**CITY OF ALBUQUERQUE
Planning Department
February 22, 2006
DRB Comments**

PROJECT # 1004708

APPLICATION # 06DRB-00212

RE: Lot 5, Jesus Apodaca Addition/sketch plat

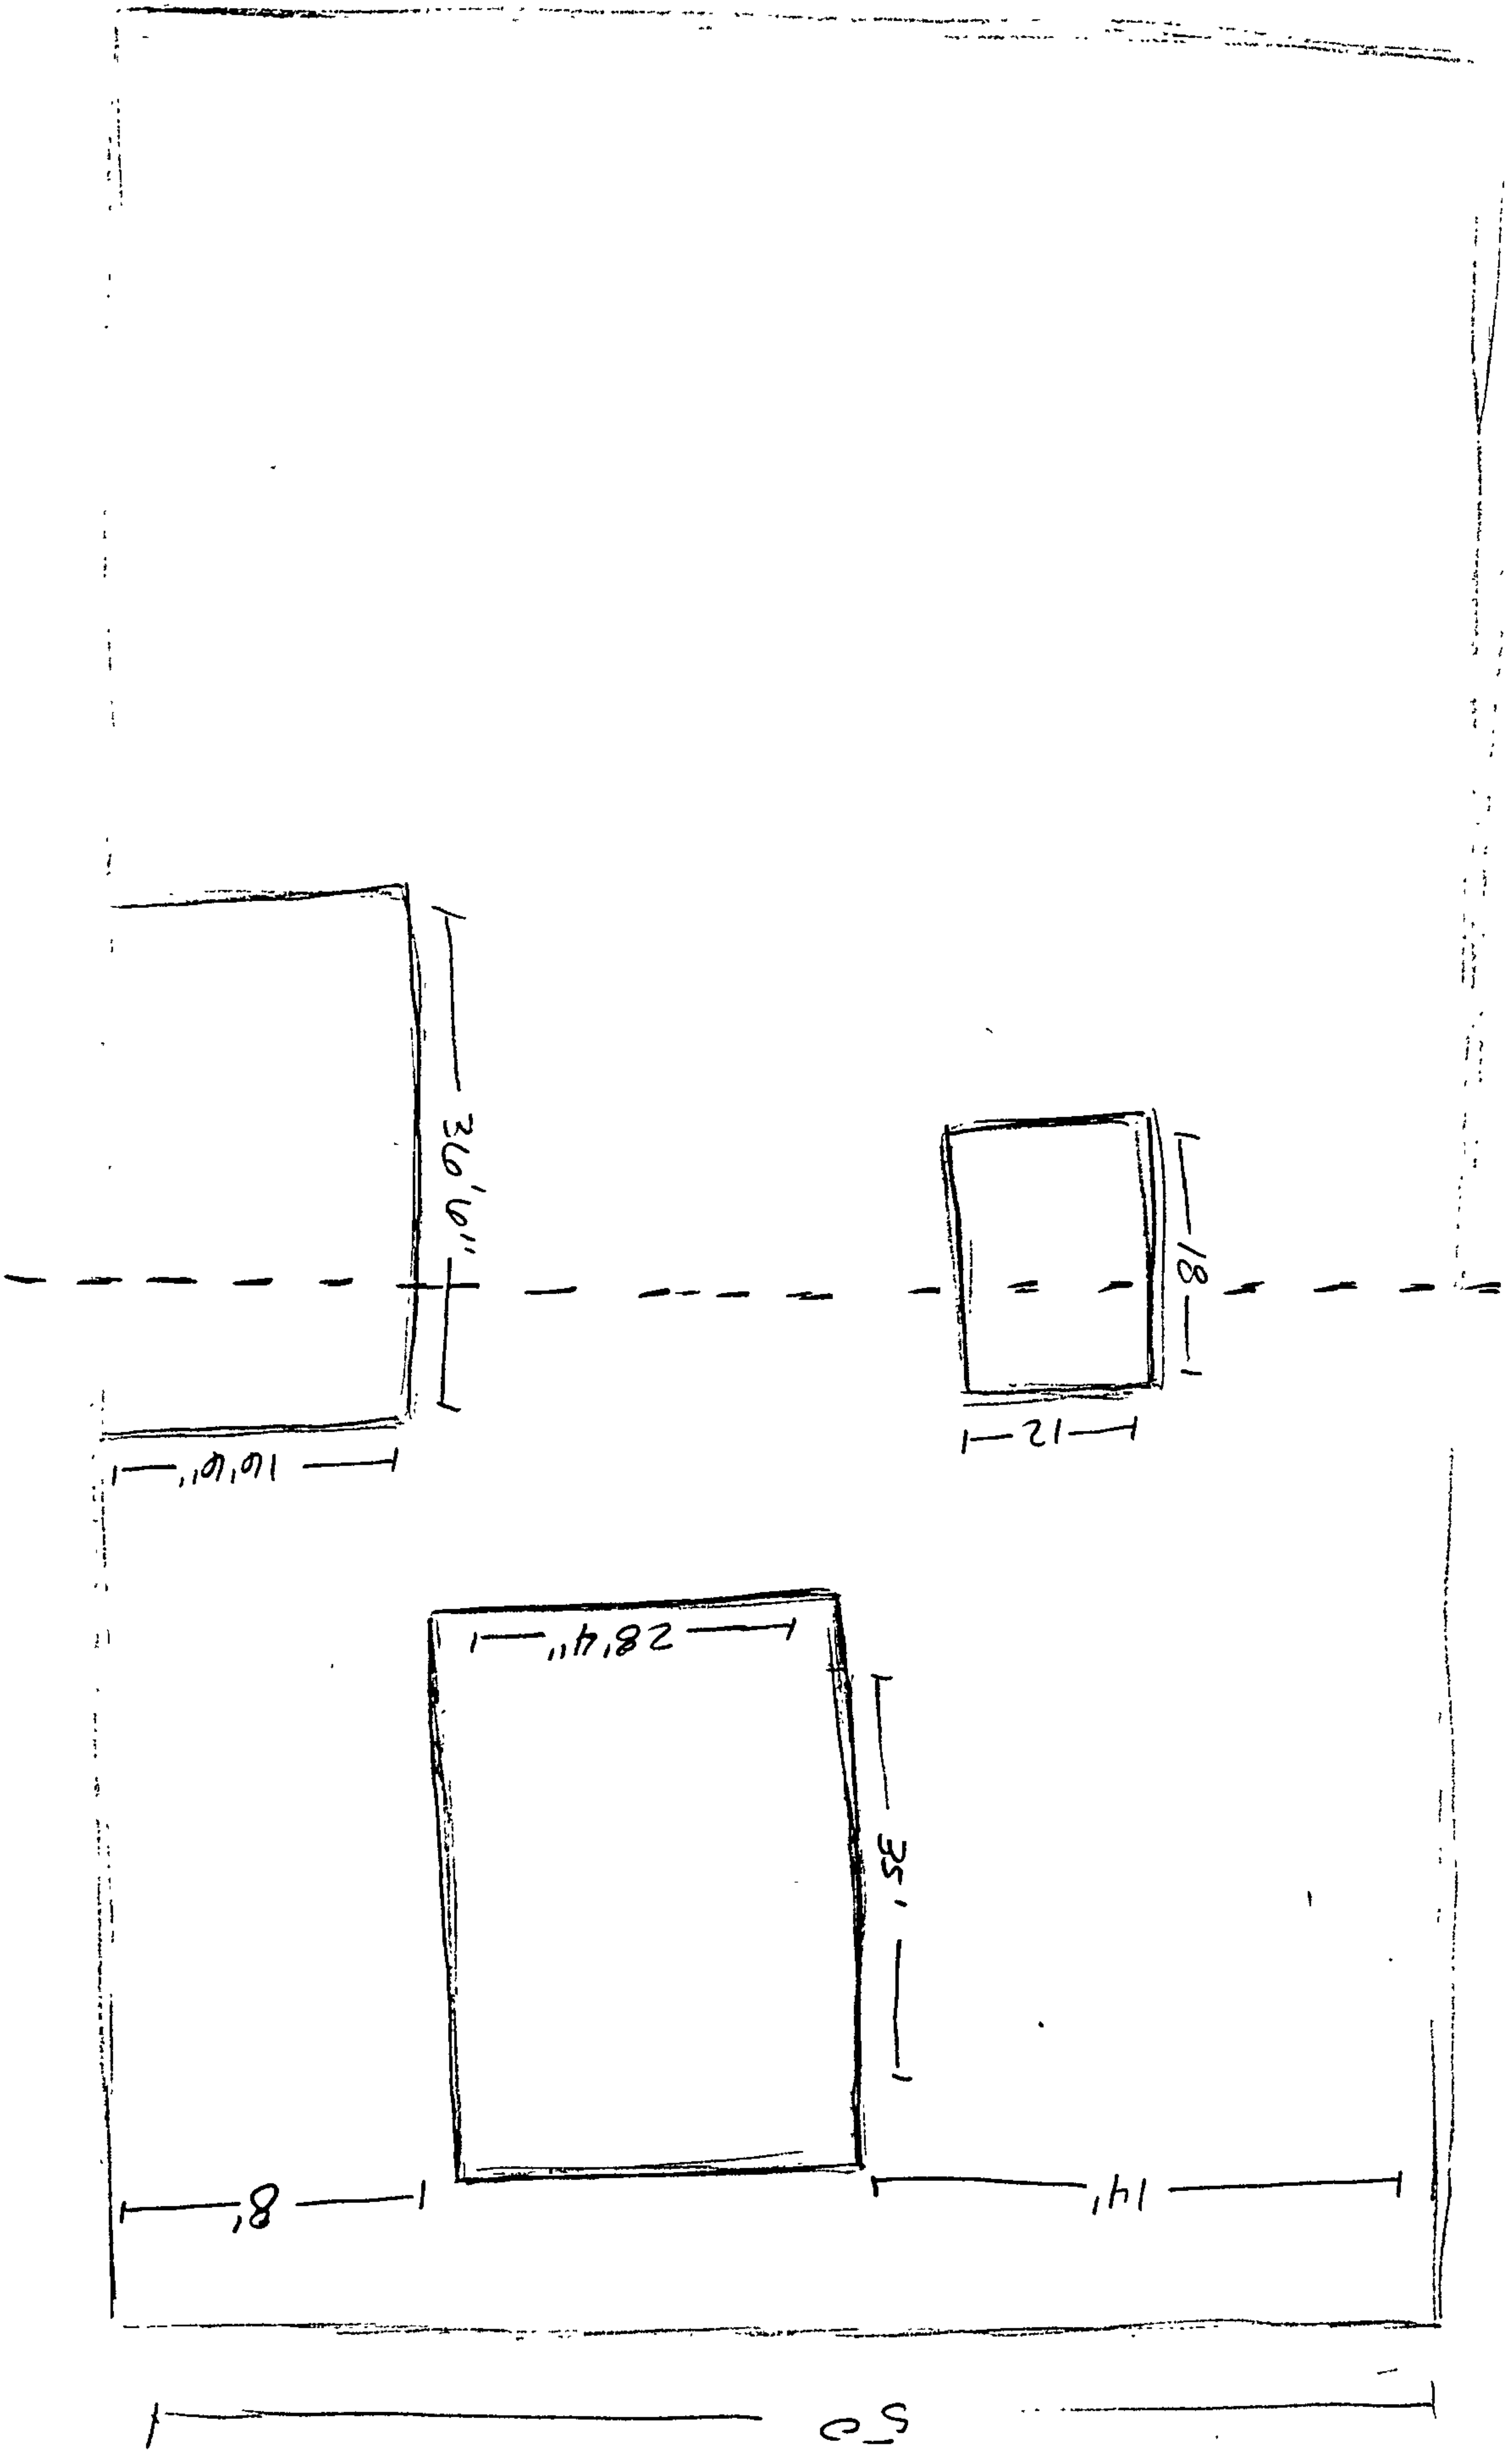
The minimum lot size for this zone corresponds to City R1 zoning. The minimum lot size is 5,000 square feet and the minimum lot width is 50 feet. The minimum lot size is not met with the proposed subdivision of Lot 5.

The minimum lot size for this zone corresponds to City R1 zoning. The minimum lot size is 5,000 square feet and the minimum lot width is 50 feet. The minimum lot size is not met with the proposed subdivision of Lot 5.
